# Access Compliance Report

## Public Rights-of-Way

Intersection ID: 51618	Main Street: SUMMERFORD_DR	Cross Street: PROSPERITY_CHURCH_RD	Location: SE
ADA ID: A9A0543B0CFC	Ramp Type: PerpDiag	Initial Pass/Fail: Fail	Overall Compliance: No
Severity Score: 10			
Codes/Mitigation Info/Possible Solution		Field Measurements/Component Compliance

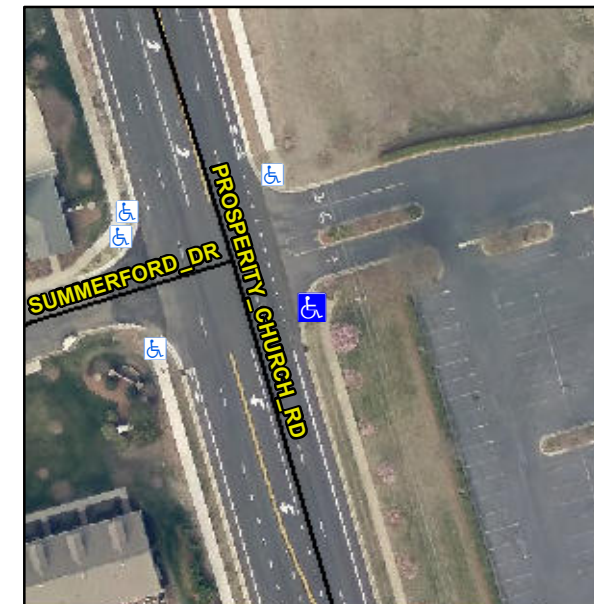
**Remove & Replace Curb Ramp With Two New Directional Ramps or Equivalent.**

**R304.5.1, R304.5.3**

Compliance	Description	Data	Compliance	Description	Data
N/A	Ramp Length (in)	92.0	Yes	Ramp Slope (%)	8.3
No	Ramp Width (in)	45.5	No	Ramp XSlope (%)	3.0
N/A	Flare Type LT	N/A	N/A	Flare Type RT	N/A
N/A	Flare Slope LT (%)	N/A	N/A	Flare Slope RT (%)	N/A
N/A	Flare Traversable LT?	N/A	N/A	Flare Traversable RT?	N/A
N/A	Landing Length (in)	N/A	N/A	DWS Provided?	N/A
N/A	Landing Width (in)	N/A	N/A	DWS Contrast?	N/A
N/A	Landing Slope (%)	N/A	N/A	DWS Length (in)	N/A
N/A	Landing X Slope (%)	N/A	N/A	DWS Full Width?	N/A
N/A	Landing Curb? (Y/N)	N/A	N/A	DWS Offset (in)	N/A
N/A	Shared Landing?	N/A			
N/A	Gutter Ponding?	N/A	N/A	Gutter Slope (%)	N/A
N/A	Gutter Lip Ht (in)	N/A	N/A	Gutter X Slope (%)	N/A
N/A	Painted X Walk1?	No	N/A	Painted X Walk2?	No
	X Walk 1 Direction	To N		X Walk 2 Direction	To W
N/A	X Walk 1 Width (in)	N/A	N/A	X Walk 2 Width (in)	N/A
	X Walk 1 Slope (%)	1.1		X Walk 2 Slope (%)	1.8
	X Walk 1 X Slope (%)	5.8		X Walk 2 X Slope (%)	16.0
